# The Rail Central Rail Freight Interchange

## Northampton Gateway Examination

Response to ExA's Further Written  
Questions (ExQ2) on behalf of Ashfield  
Management Limited and Gazeley  
GLP Northampton s.à.r.l.

**26 February 2019**

### **RC Public Rights of Way Strategy – Links with NG Plan**

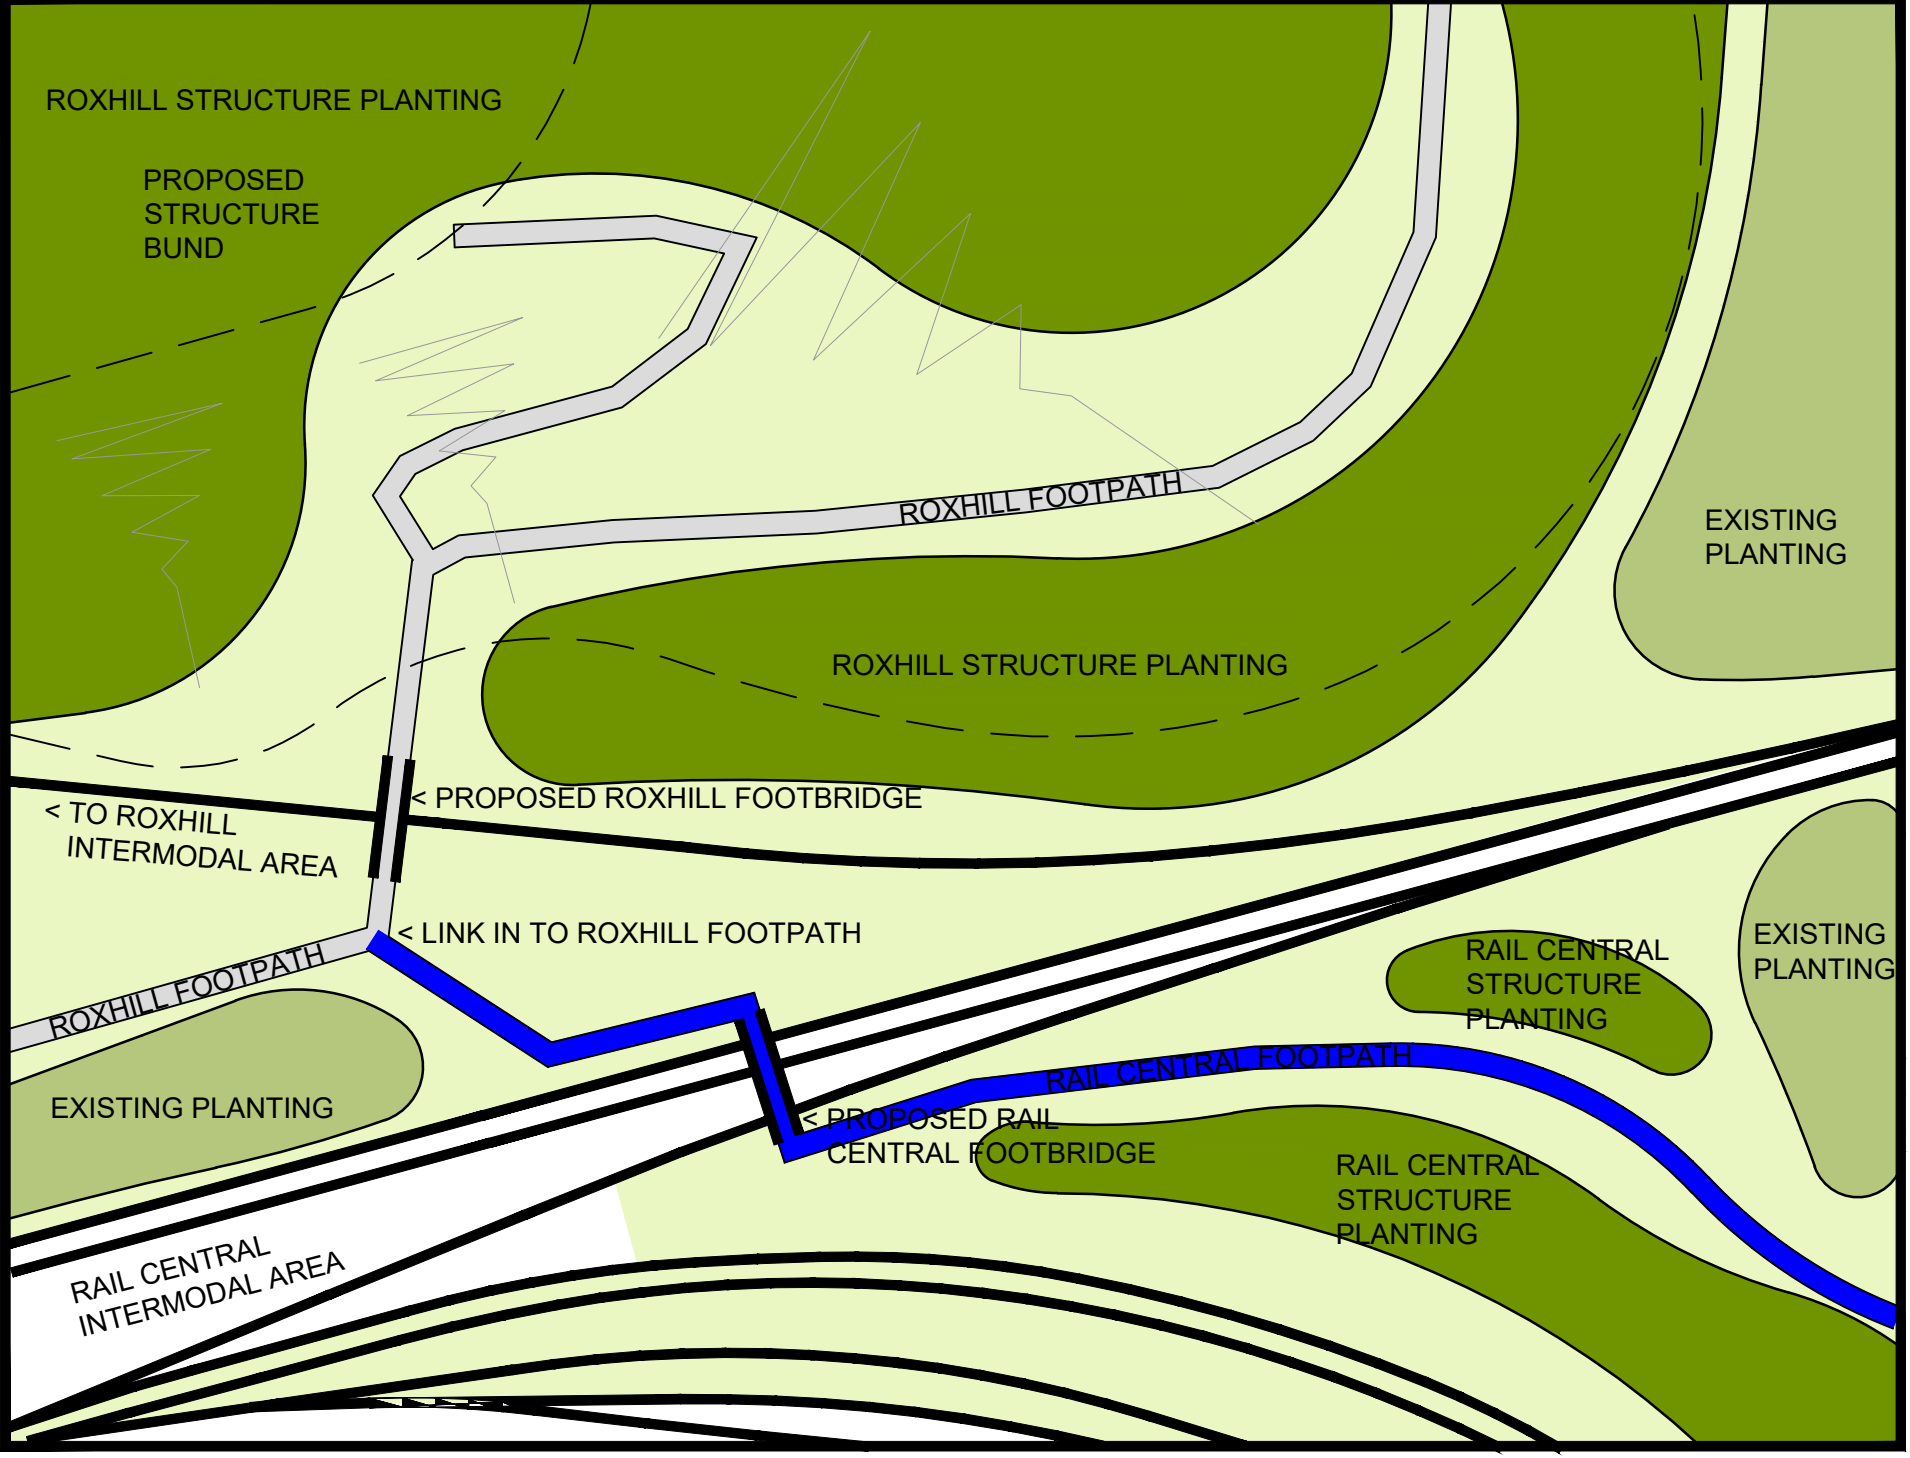
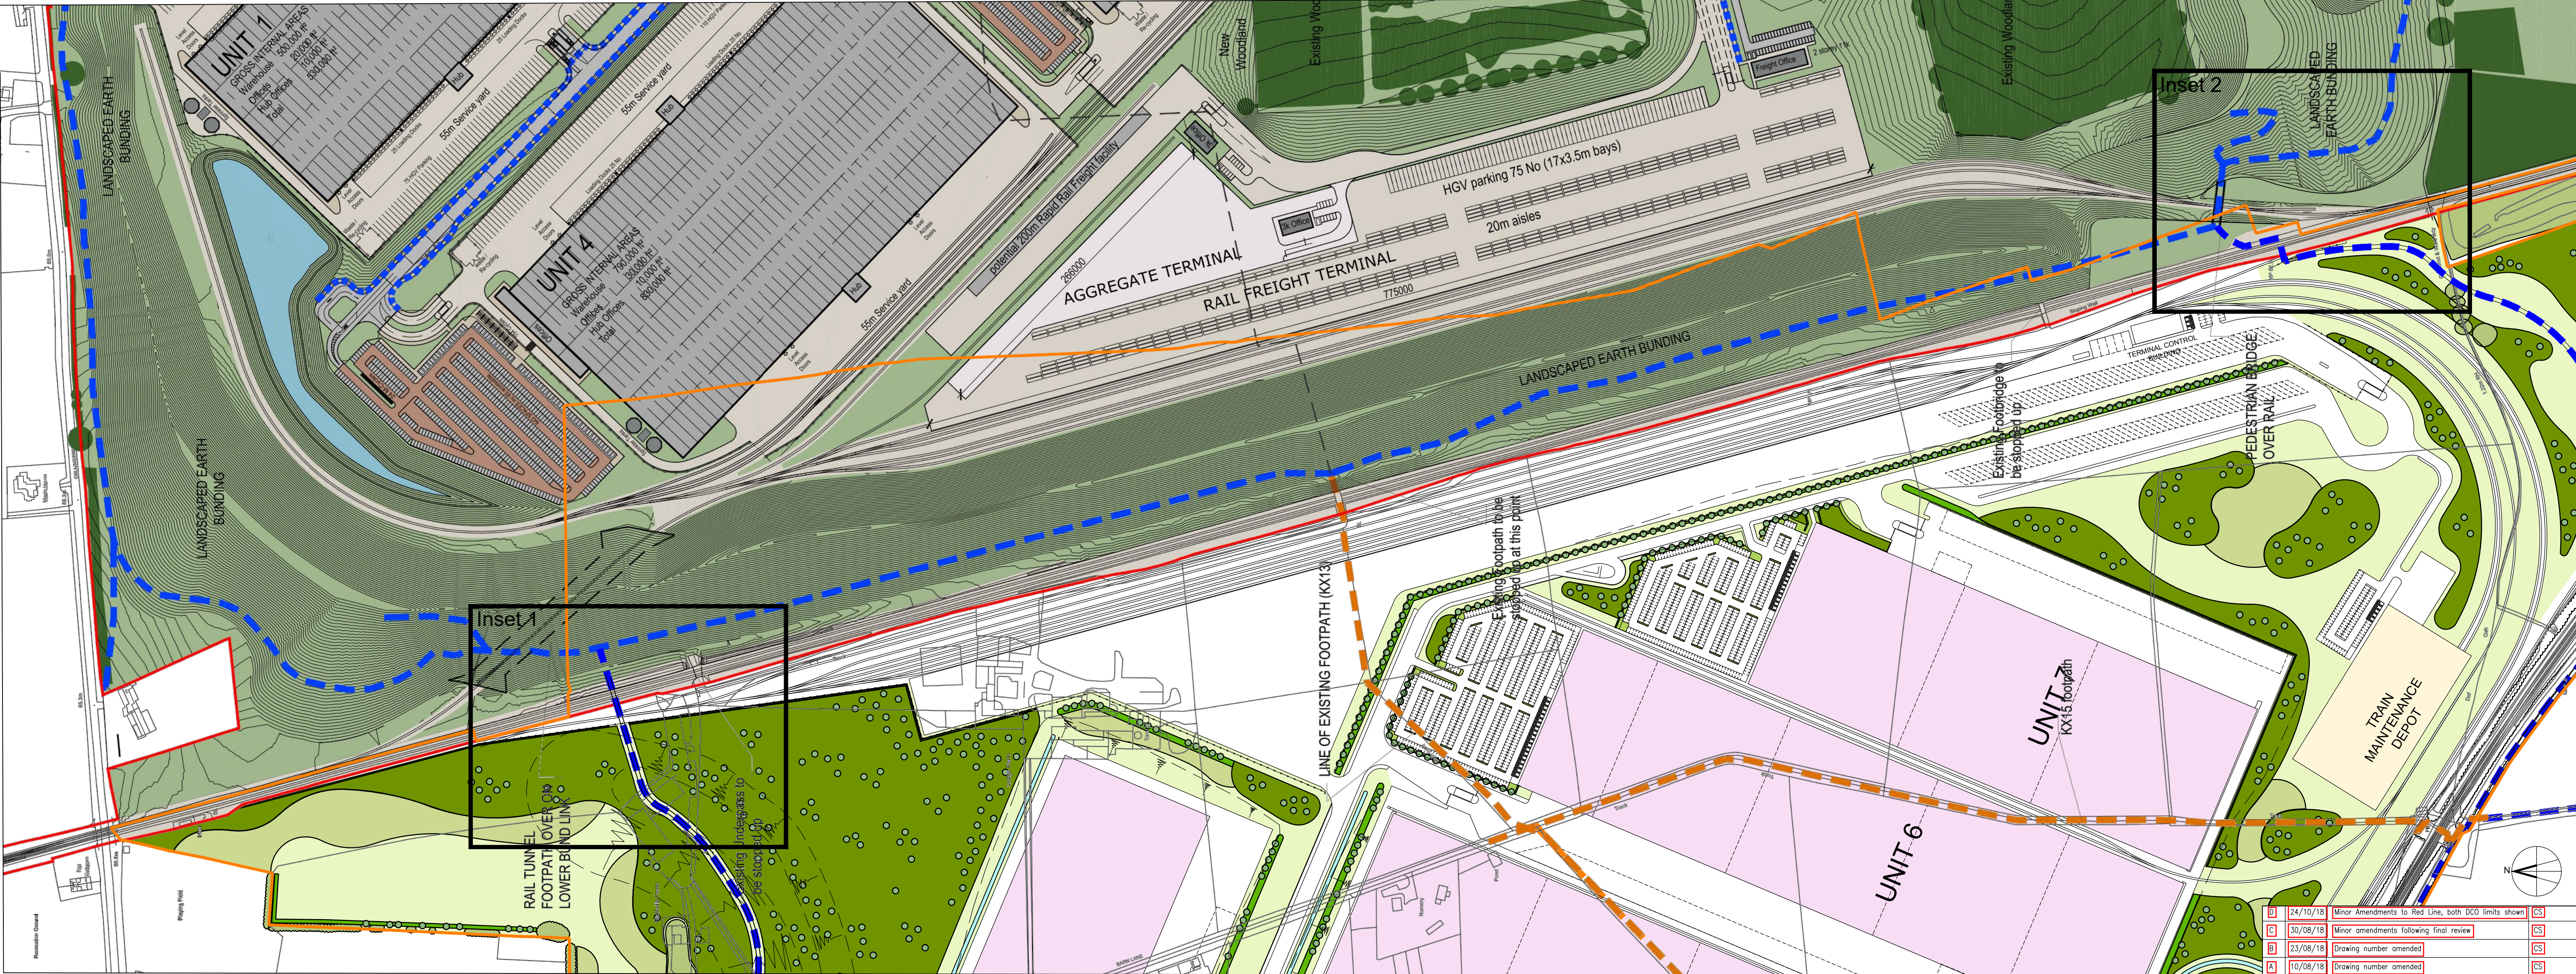
- 1.12 RC has reviewed the footpath connections plan [REP4-027] put forward by NG. NG's proposed location of Footpath Connection B is further south to the location proposed by RC in its DCO application. This location is outside of RC DCO Order Limits. Consequently, RC cannot deliver NG's suggested location of Footpath Connection B under the RC DCO as submitted.

- 1.13 RC has requested that the location of Footpath Connection B, as shown within Inset 2 of the Interrelationship Report plan marked 'Public Rights of way Strategy – Footpath Links with Northampton Gateway' [Appendix 3, page 31 of REP1-030] and also attached as Appendix 1, is substituted instead, which is capable of delivery by RC within the powers sought under the RC DCO.
